July 18, 2014
L-2014-197
10 CFR 2.390
10 CFR 50.90

Re: Turkey Point Nuclear Generating Station Units 3 and 4
Docket Nos. 50-250 and 50-251
Response to Request for Additional Information Regarding License Amendment
Request No. 216 - Transition to 10 CFR 50.48(c) - NFPA 805 Performance-Based
Standard for Fire Protection for Light Water Reactor Electric Generating Plants (2001
Edition)

**Response to Request for Additional Information Regarding
License Amendment Request No. 216**

**Florida Power and Light Company
Turkey Point Nuclear Generating Station Units 3 and 4
Transition to 10 CFR 50.48(c) – NFPA 805
Performance-Based Standard for Fire Protection for
Light Water Reactor Electric Generating Plants, 2001 Edition**

Figure 1
 Markup of Turkey Point Drawing 5610-E-128

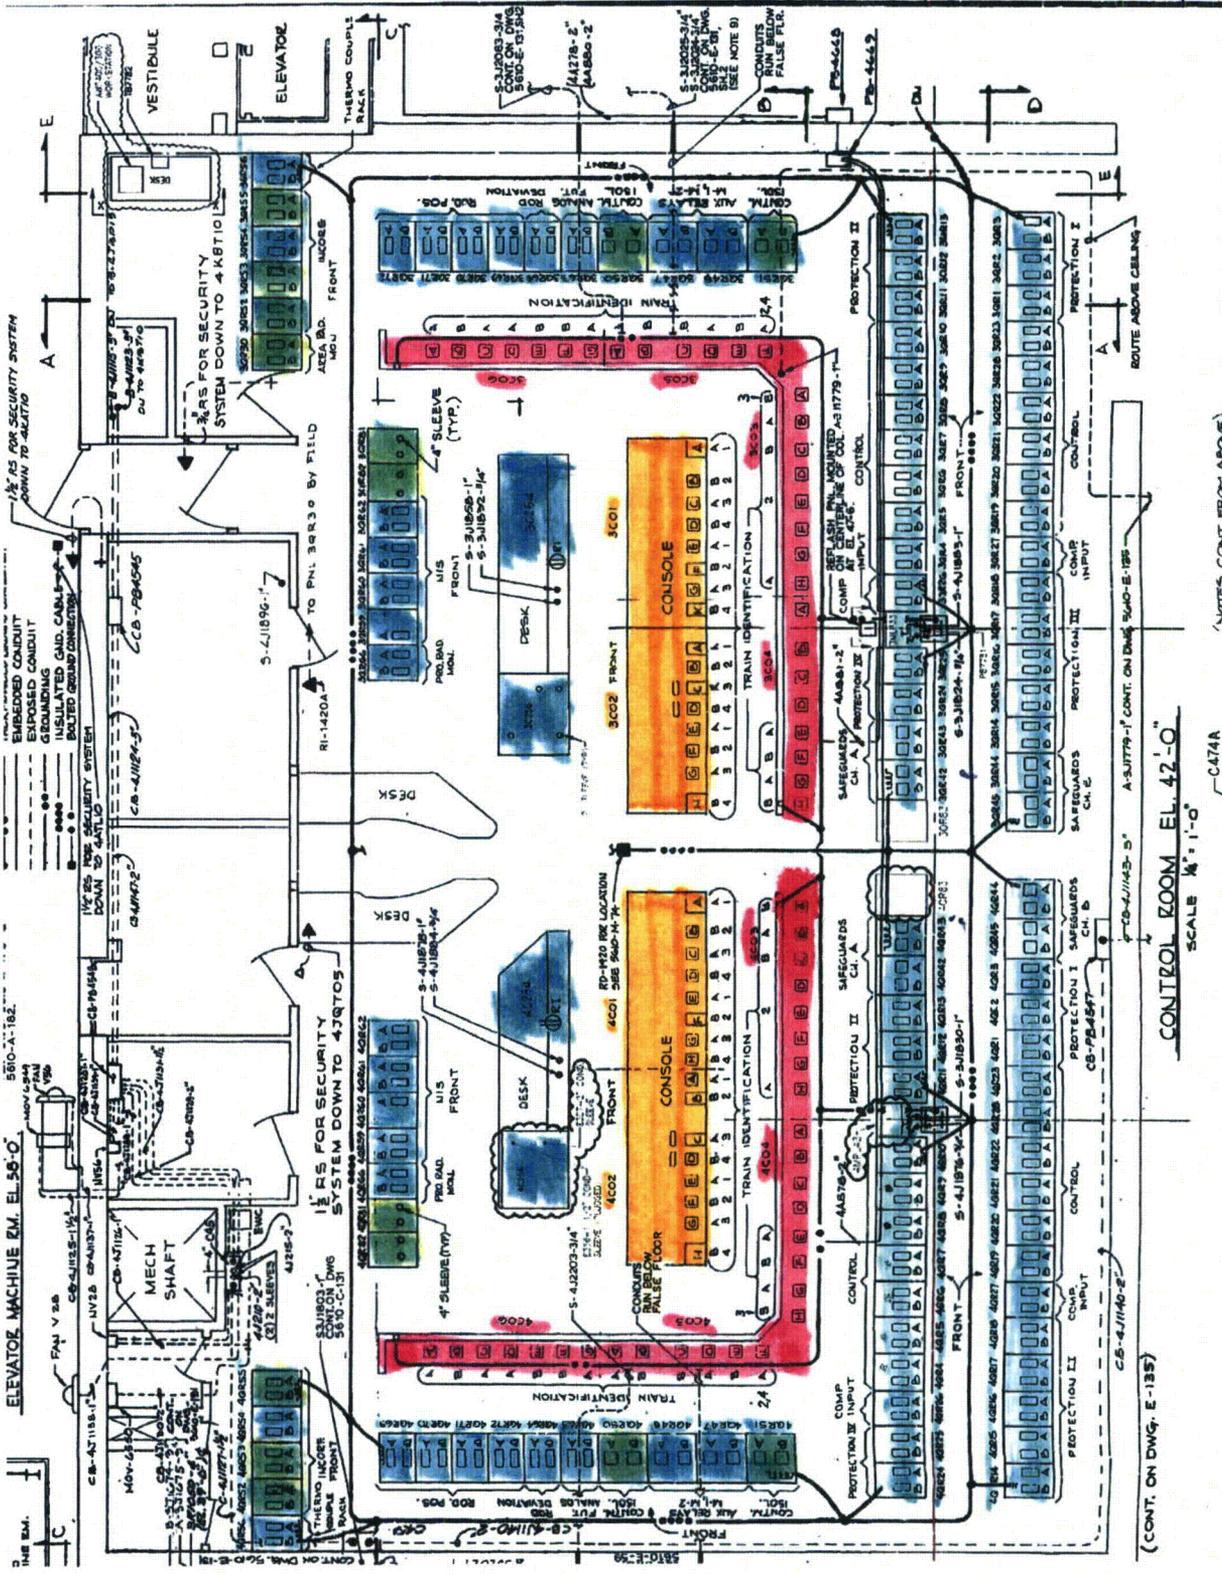
The April 4, 2014, response to RAI PRA 01.r.02.c states that "scenarios have been created for the back panels in which adjacent panels are assumed to be impacted from fire propagation." Briefly summarize how the method to consider propagation of fire beyond the ignition source cabinets in the back panels of the main control room aligns with the approach recommended in Appendix S of NUREG/CR-6850. If the approach differs, provide justification for its use.

The Turkey Point Main Control Room includes two types of panels in the “back panel area”. The first type is the main control board vertical boards (3C03, 3C04, 3C05, 3C06, 4C03, 4C04, 4C05, 4C06), located behind the main control board. These panels are open back panels which form an “L” shape with two panels on each side of the “L” with the closed side of the panel and the opening of the “L” facing the unit’s main control board console and the opposite unit. The second type of panel in the “back panel area” is a stand-alone panel configuration which faces the open side of the open vertical board. These panels are separated from each other by double wall and air gaps. Figure 1 is a markup of Turkey Point drawing 5610-E-128 which highlights the following:

- Main control board (orange),
- Main control board open back panels (pink) and
- Stand-alone panels (blue/green, no significance in the two colors used).

The analysis of the open back panels assumes a fire in each panel will spread to one adjacent panel. Scenarios are evaluated for the following panel combinations:

The analysis of the stand-alone back panels is based on no fire spread between these back panels where double wall and air gap configuration exists (most of these panels have double wall air gap between them; in cases where they do not, the fire is assumed to impact both adjacent panels). Transient fires are postulated between the open back panel and the stand-alone panels which face the open back panels. Each transient fire scenario is assumed to impact the adjacent open back panel section and two adjacent stand-alone panels. Such scenarios are postulated for each combination of two stand-alone panels and the open back panel which faces them. For transient fires at the centerline between the adjacent open back panels both of these panels are assumed to be impacted.

This methodology is consistent with that specified in NUREG/CR-6850, Appendix S. A summary of the guidance in Appendix S and how the guidance is addressed in the evaluation of the back panel area is provided below:
